Dear Council,

We are the owners of the property to the immediate south [REDACTED] We note the following concerns.

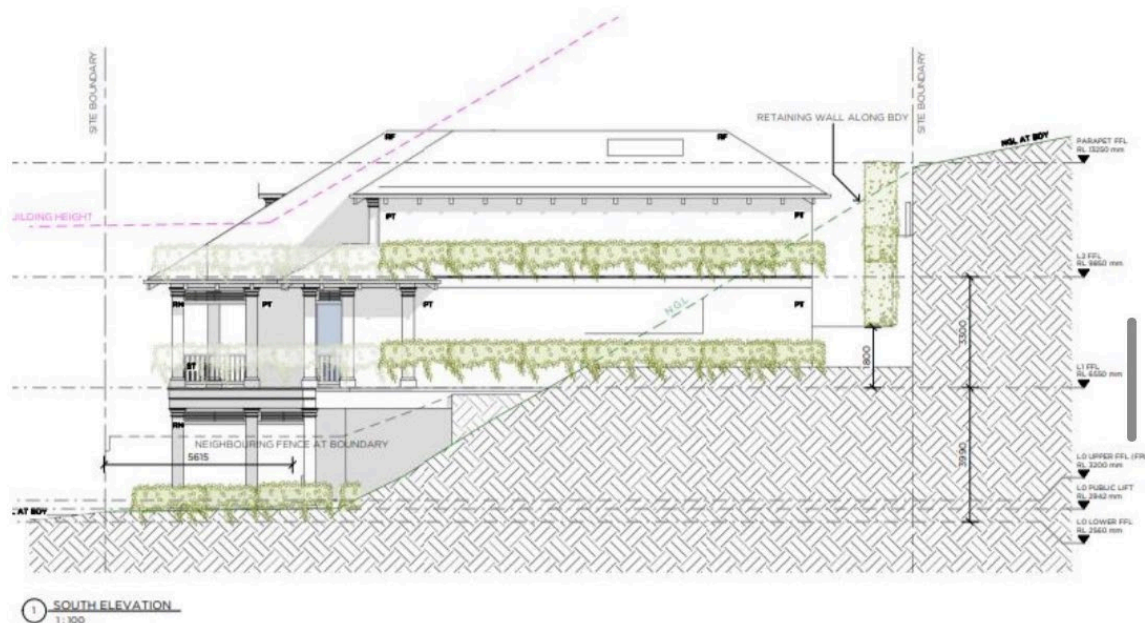
1. Non compliant height & bulk significantly affects the amenity of our home

The proposed height breach of almost c.12m is extreme, significantly eclipsing both heritage listed Barrenjoey House and our home. The size/bulk totally “hems” us in, as most of our home is set back from the road and totally overwhelms us, wherever we are in our property. We have view loss impacts of water views, as well as views of the Heritage listed Norfolk pines, and up to the north of the site. This is a direct result of the height/excess bulk/encroachment of the building envelope near our side of the property. The amenity of our private open space, and entertaining deck is affected by the “caged in” feeling, and we would receive less solar access than a design that adheres to the height, setback and envelope controls. We ask council to please recognise this. This was also pointed out by the Design & Sustainability Panel’s report. The size of the 2 apartments on the non compliant third level is very excessive, 4 bedrooms and 5 bathrooms each.

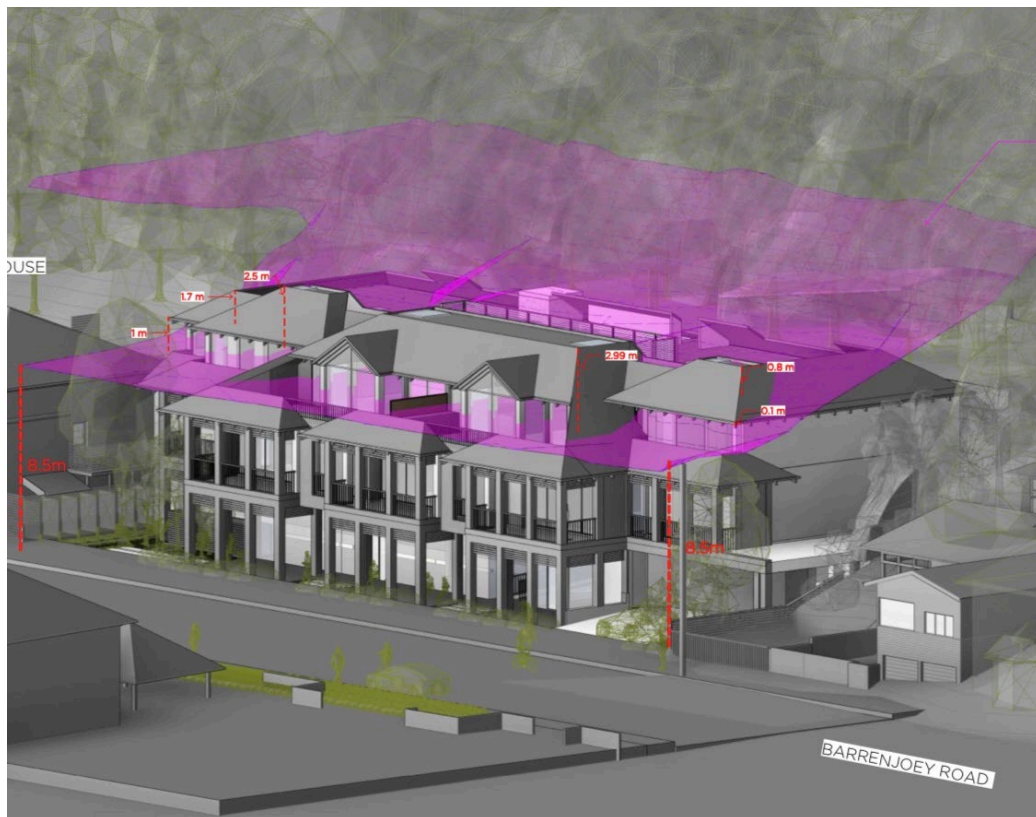
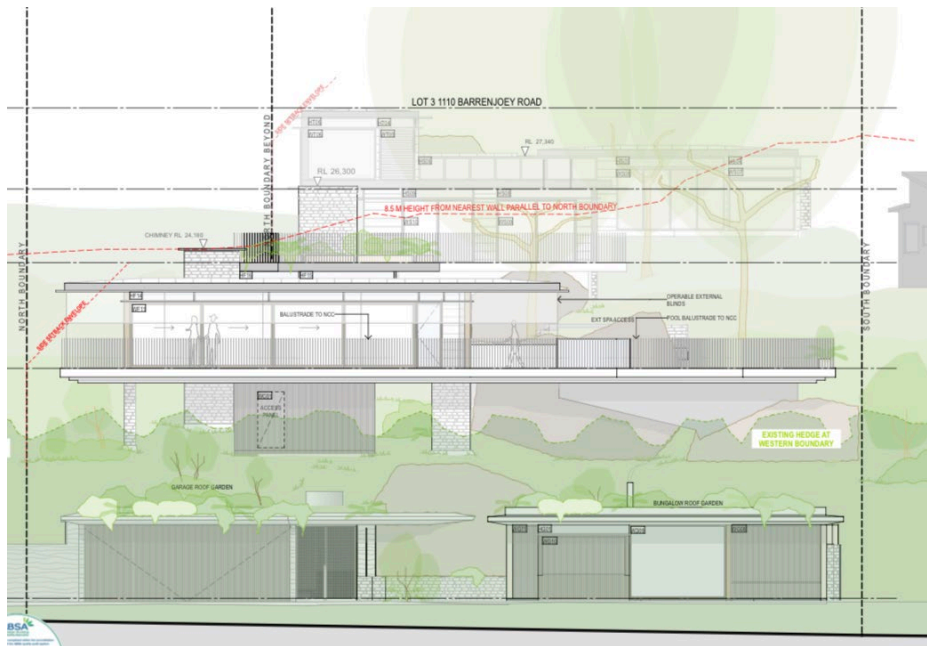
The Geotech report has not been updated for the new plans and design. And to add further insult, the detail in the existing one is also grossly deficient. This is a basic requirement for submission. The shared rock on the boundary at the site of proposed deep excavation extends under the footings of our house. This Geotech report is an extremely important consideration for the assessment of the impact to our property. We implore council to ensure they/we are given a detailed report ASAP so we can properly consider and understand the risks to our house/land.

How did this happen and why should we, facing proposed 10m+ significant excavation right ON our boundary (and shared rock) have not been furnished with this already? It's unacceptable and we are very disappointed council failed to check this basic requirement of the plans matching the report. We deserve a fair process as rate payers and adjoining land owners.
